REQUEST

Current Zoning: N1-A (neighborhood 1-A)
Proposed Zoning: N1-F(CD) (neighborhood 1-F, conditional)

SUMMARY OF PETITION

The petition proposes to develop two triplex buildings and one quadplex on two parcels currently developed with two single family detached homes.

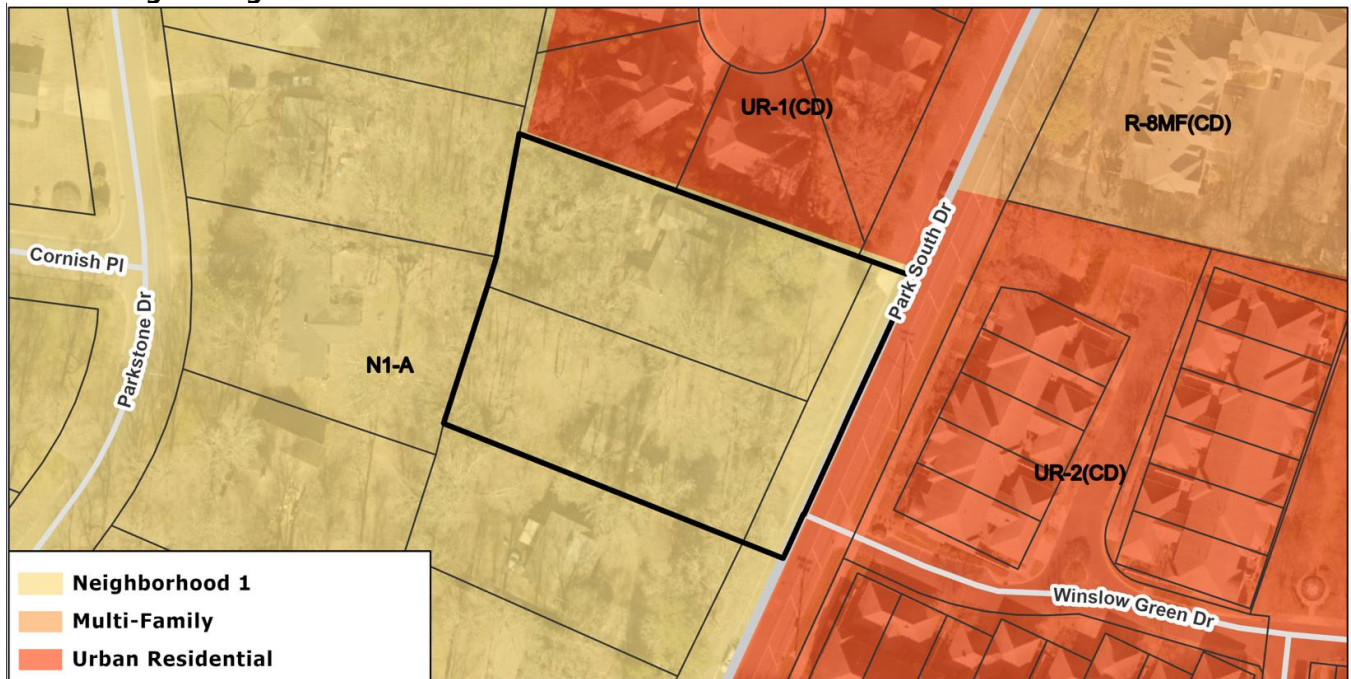
• Proposed Request Details

The site plan accompanying this petition contains the following provisions:

- Allows a multi-dwelling development with up to ten units, two triplexes and one quadplex.
- Commits to install a Class C Landscape Yard around the perimeter of the site.

- Provides Transportation Provisions:
 - Access via one driveway from Park South Drive.
 - Commits to construct an 8' planting strip and 8' sidewalk along the site's frontage.

- Commits to construct an ADA compliant bus stop in coordination with CATS.
- Notes that freestanding lighting fixtures will be fully capped and shielded.

- Proposes a tree save area at the site's rear.
- Notes that the petitioner intends to connect site stormwater discharge to the existing Charlotte storm pipe system located west of the site, either on-site or off-site. The petitioner will make a good faith effort to secure a storm drainage easement from an adjoining property owner, however, if existing storm pipe infrastructure does no exist on-site the petitioner is obligated to connect underground.
